REQUEST FOR INFORMATION **DATE:** June 02, 2016 **NO.:** RFI-148

Project Name: 15051-Webster University Interdisciplinary Science Building Project No.: 15051

Subject: Paver slab area sloped concrete and Roof drains

Roof Drains

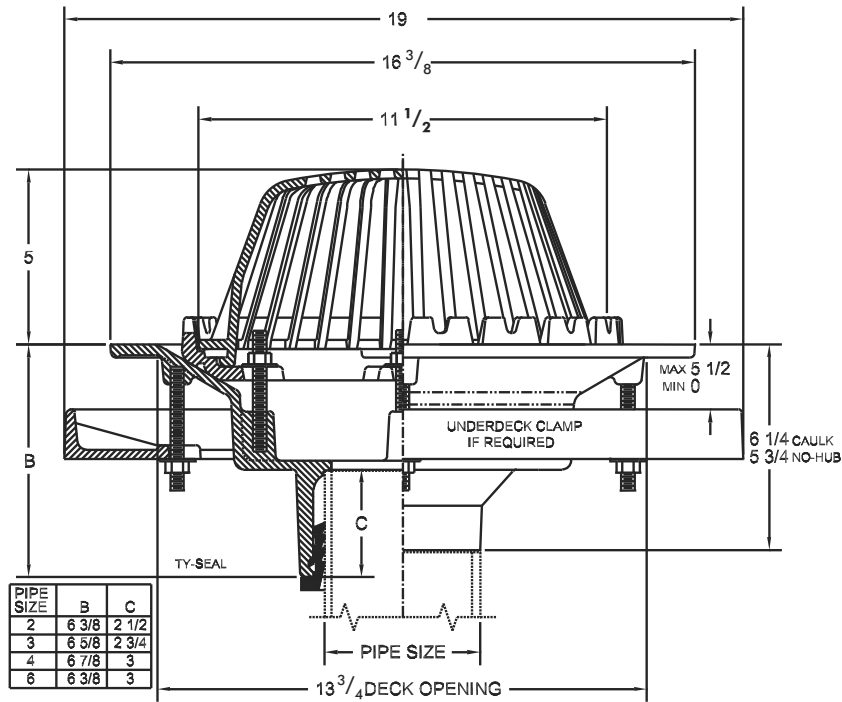
Detail 16/S301 indicates elevated slab should be sloped to drain per Arch drawings. Note 1 on A423 indicates the slab to be sloped to drain per structural documents. S0103 indicates top of steel in these areas to be – 1' 5 1/2" with a top of slab to slope per arch documents. Please confirm the top of steel elevation and bottom of metal decking is to remain FLAT at – 1' 5 1/2 " and the concrete thickness shall be a minimum of 6 1/2" thick and increase in thickness to accommodate the requested slope. If this is the case, please confirm roof drain body elevations indicated on A423 as these appear they will be higher than the proposed sloped slab elevations. Drain product data attached.

T/STEEL IS FLAT AT 98'-6 1/2" (-1'-5 1/2"). SLAB THICKNESS AT DRAINS IS 5 1/2". SLAB THICKNESS INCREASES SLOPING UP AWAY FROM THE DRAINS TO THE EDGES WHERE IT IS 6 1/2" (NOT CONSIDERING CURB). T/SLAB AT DRAINS = 99'-0", T/SLAB AT EDGES = 99'-1" (NOT CONSIDERING CURB).
